Application for Variation of an Environmental Permit

C1. Name of the Current Environmental Permit Holder :  
CLP Power Hong Kong Limited  
C2. Application No. of the Current Environmental Permit : FEP-01/341/2009/A  
C3. The Current Environmental Permit was Issued in : month / year  
04 / 2021

# Hong Kong Offshore Wind Farm in Southeastern Waters

Environmental Review Report for Proposed Cable Route

Figure 1.1

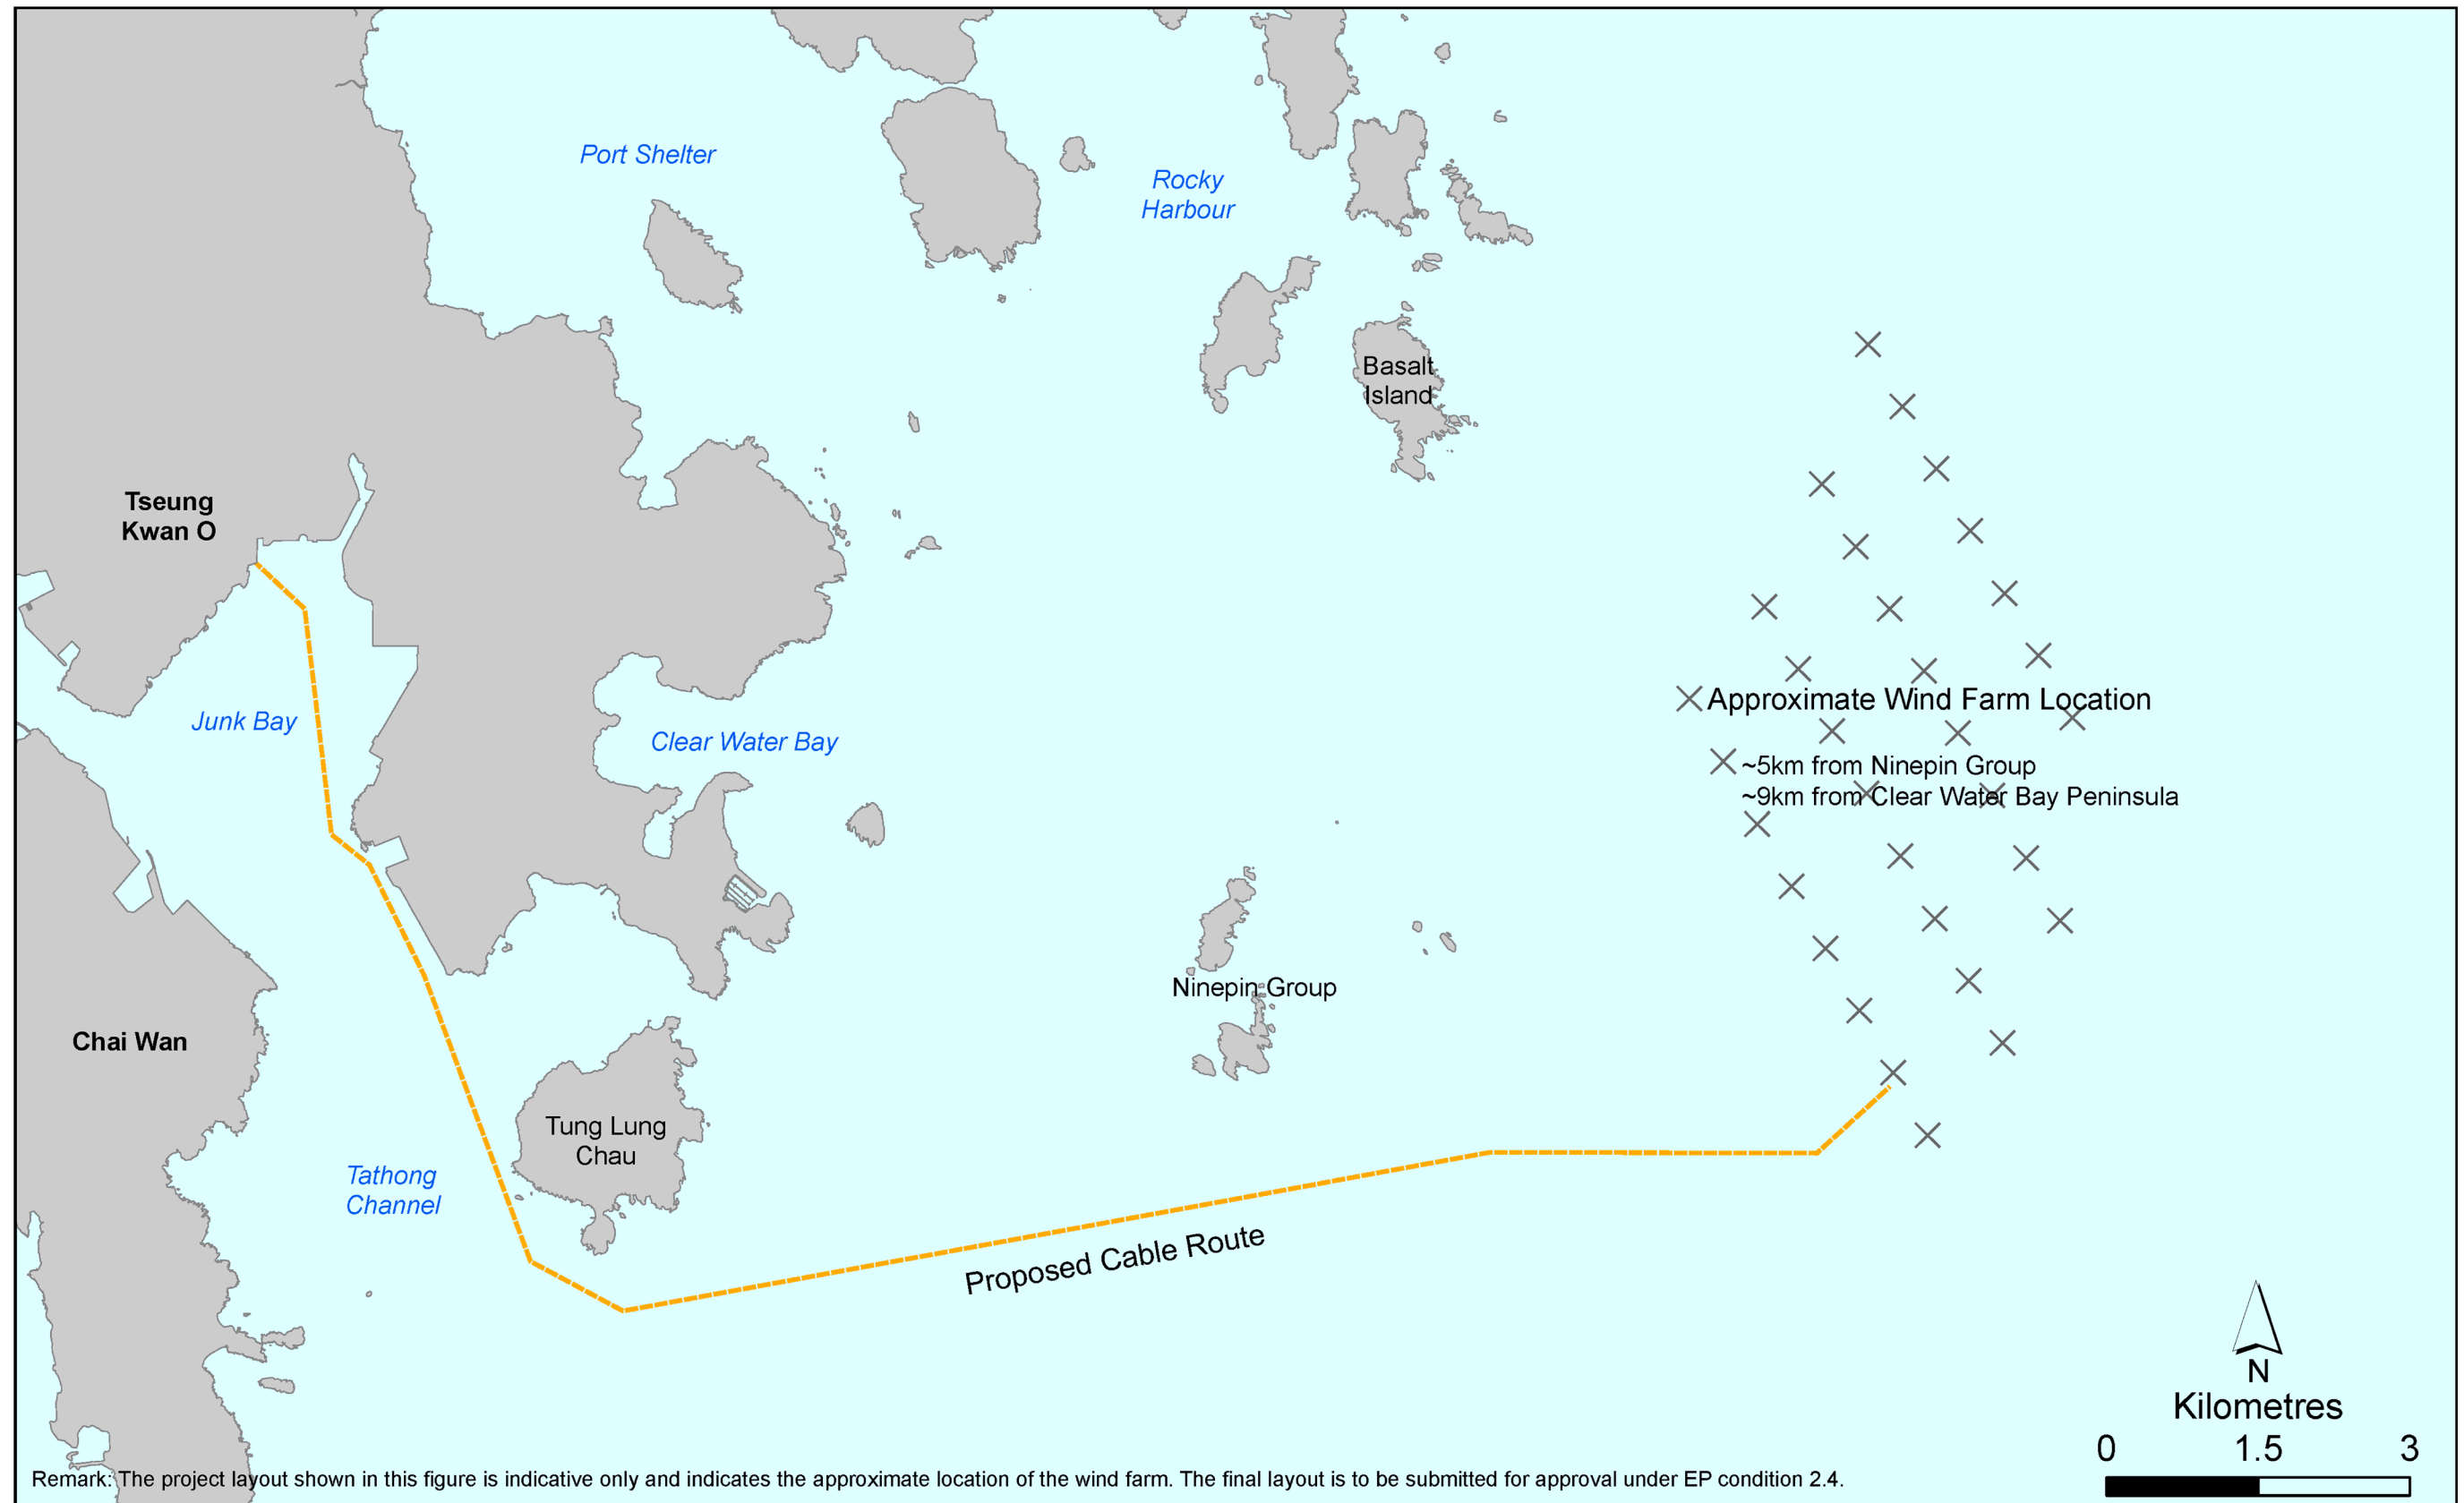
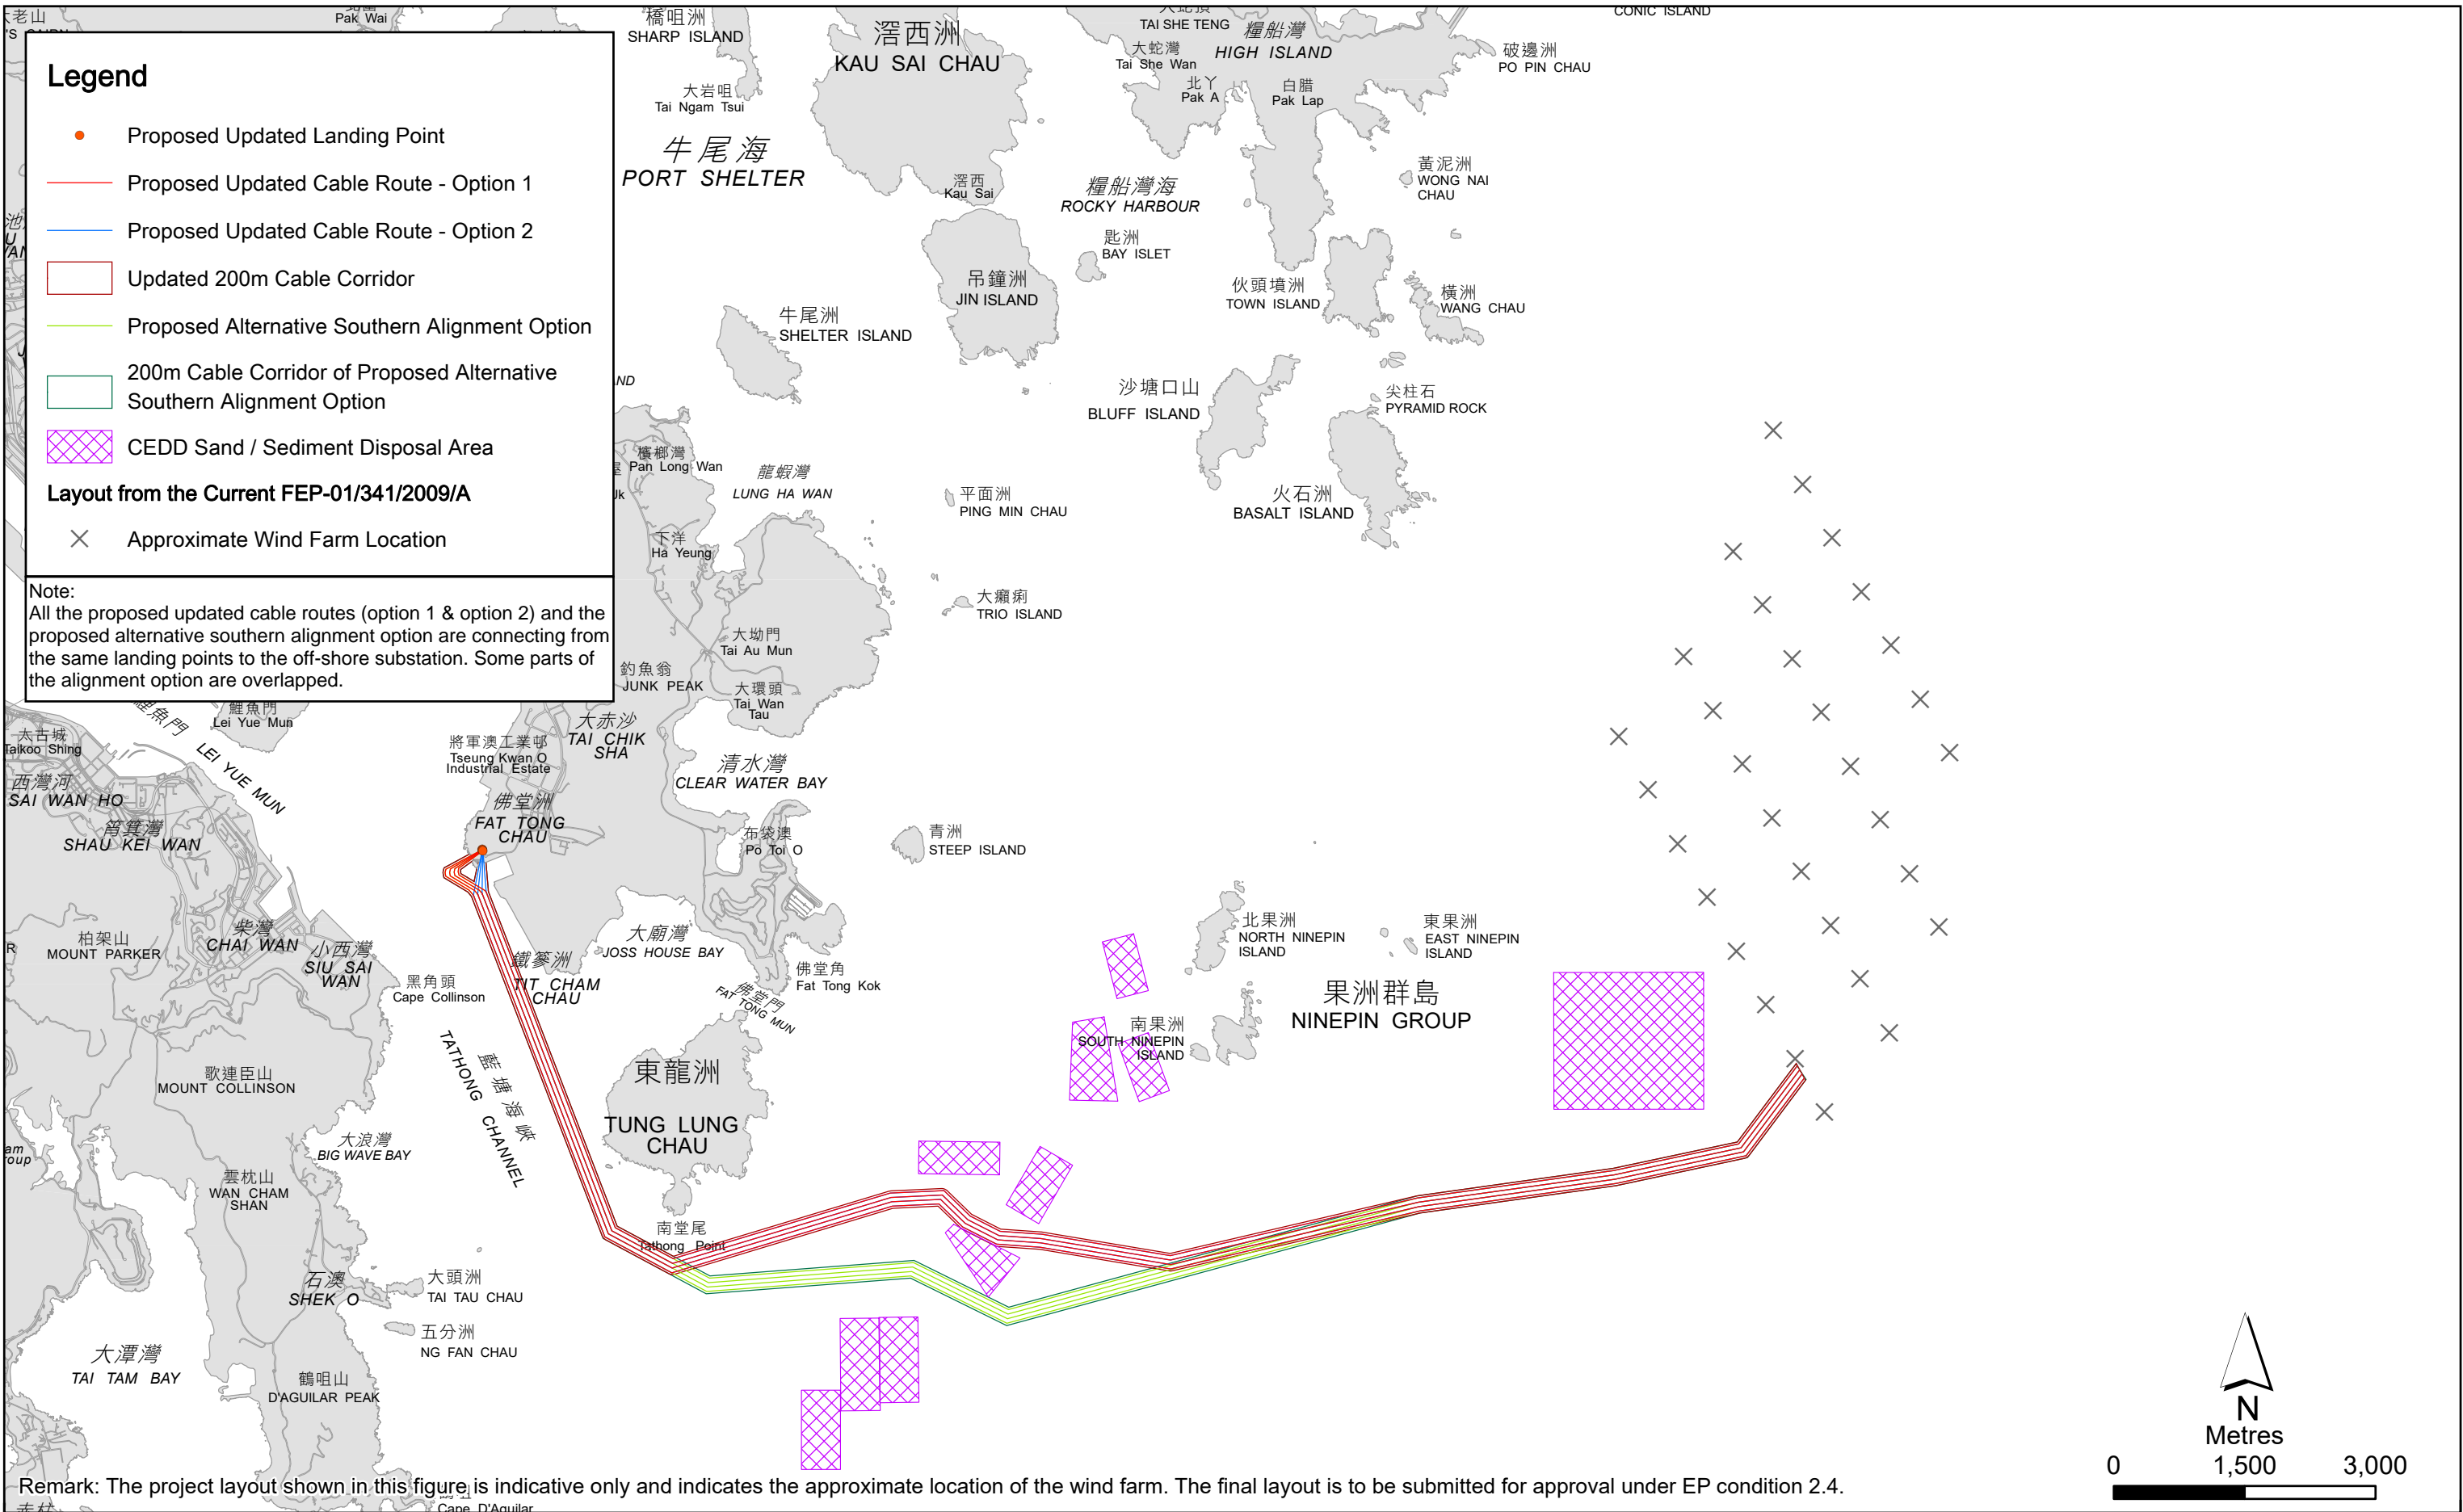
Condition	Current FEP	Proposed Variation	Reason for Variation
Figure 1	Location Plan (see <b>Figure 1.1</b> of the Environmental Review Report (ERR))	To be replaced with <b>Figure 1.2</b> of the ERR.	Following the proposed changes in scale and scope described below.
Condition 2.4	The Permit Holder shall submit to the Director for approval, at least six months before the commencement of construction of the Project, three hard copies and one electronic copy of the final layout of the wind farm turbines with demonstrations that the final layout, among the possible alternative layouts, has minimized the footprint of the project and maximized the distance of the turbines from Ninepin Group and Ung Kong Group.	The Permit Holder shall submit to the Director for approval, at least six months before the commencement of construction of the Project, three hard copies and one electronic copy of the final layout of the wind farm turbines, <u>cable alignment and location of cable landing site</u> with demonstrations that the final layout, among the possible alternative layouts, has minimized the footprint of the project and maximized the distance of the turbines from Ninepin Group and Ung Kong Group.	The final wind farm layout; cable alignment and cable landing site shall be confirmed by the Project Proponent at detailed design stage prior to the commencement of construction of the Project.
